Town of Hilton Head Island Regular Design Review Board Meeting

Applicant/Agent Name: David McAllister Company: Wood and Partners Inc.
 Mailing Address: 7 Lafayette Place City: HHI State: SC Zip: 29925
 Telephone: 843.681.6618 Fax: 843.681.7086 E-mail: dmcallister@woodandpartners.com
 Project Name: 1st Tee Boys and Girls Club Project Address: 151 Gumtree Road
 Parcel Number [PIN]: R 510 007 000 0271 0000 R510 007 000 0023 0000 R510 007 000 0392 0000
 Zoning District: RM-4 Overlay District(s): Corridor Overlay

BOYS AND GIRLS CLUBS
OF THE LOWCOUNTRY
171 Gumtree Road
Hilton Head Island, South Carolina

DESIGN TEAM/DRB COMMENT SHEET

SIGN/LIGHT BOLLARD

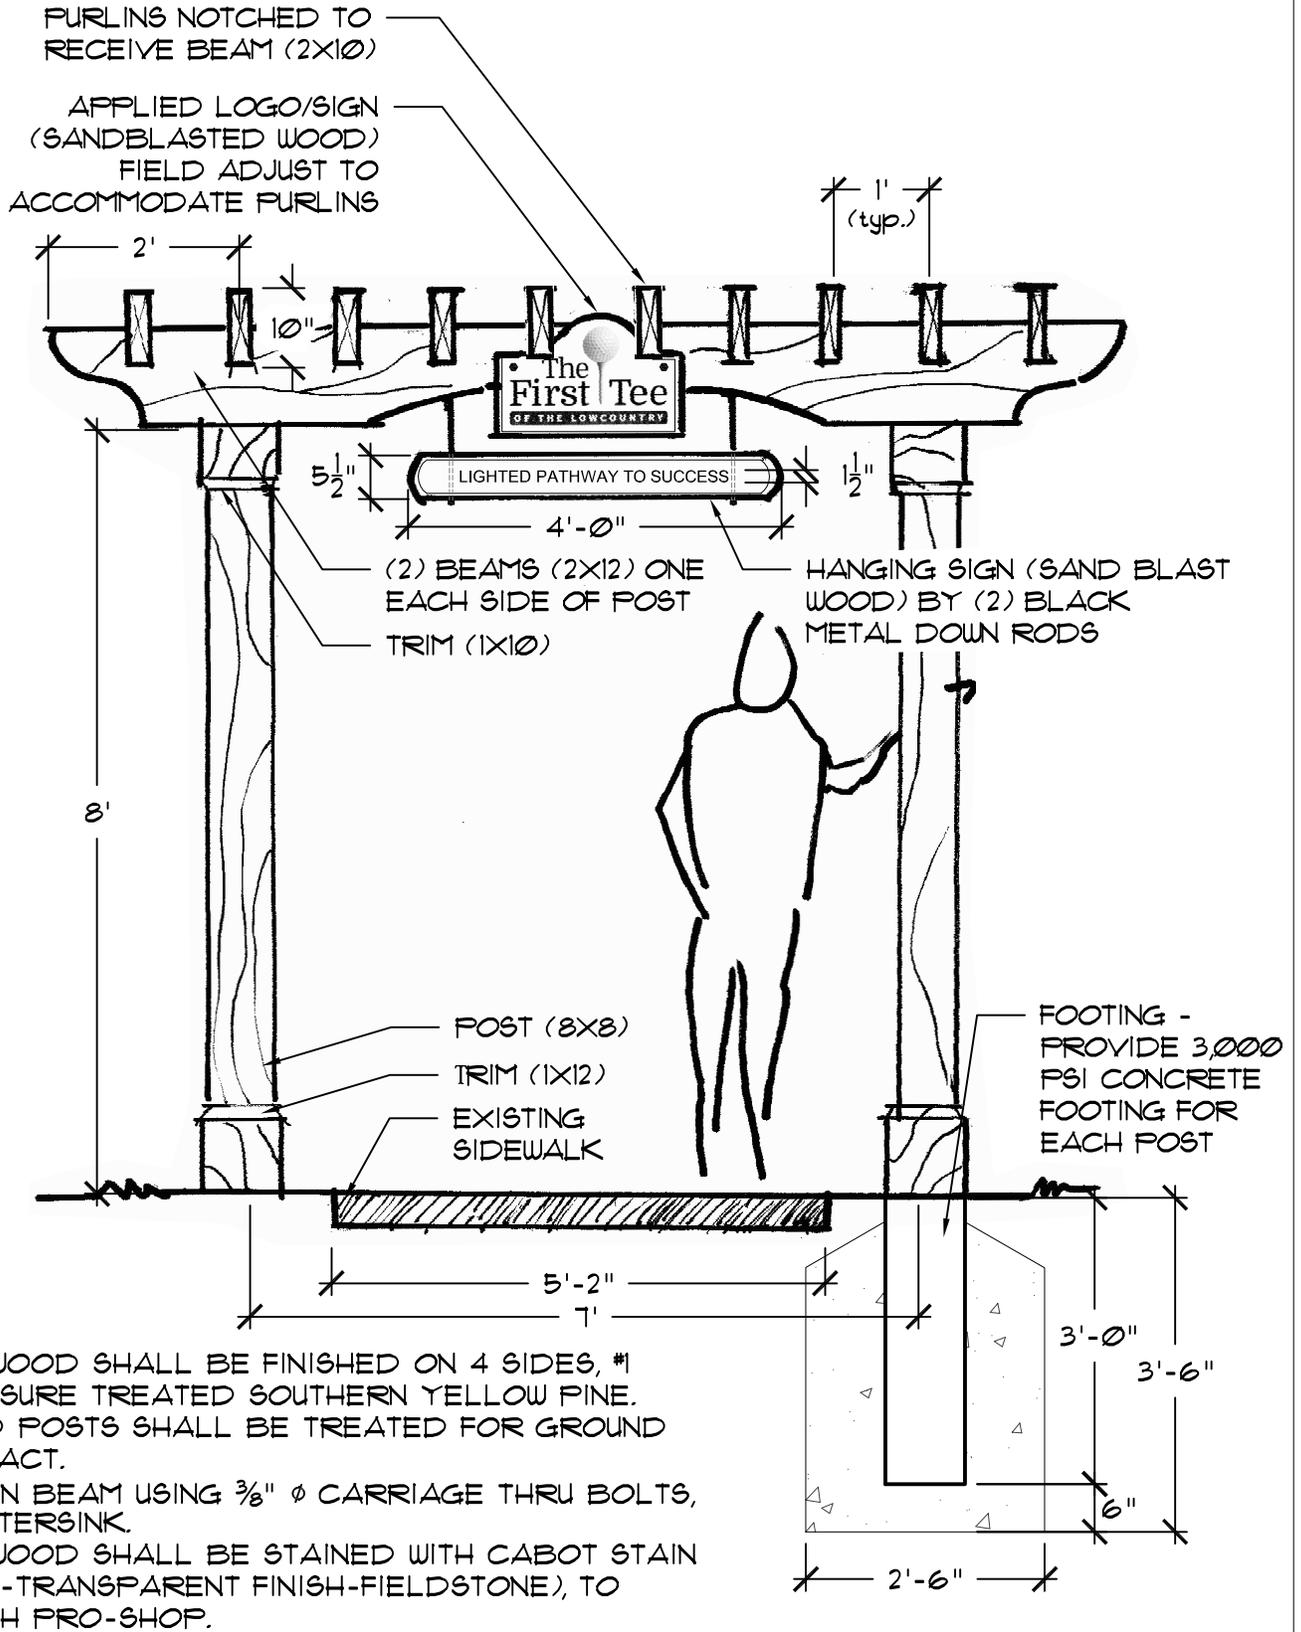
1. Finish of proposed Trellis Feature at Entrance is proposed to match clubhouse building. Consider staining existing trellis to match clubhouse building and proposed trellis.
2. Change proposed sign light from LED to other type of light allowed by LMO.
3. All proposed lights are bronze with the exception of the lighted bollards. Consider bronze lights on the bollard.
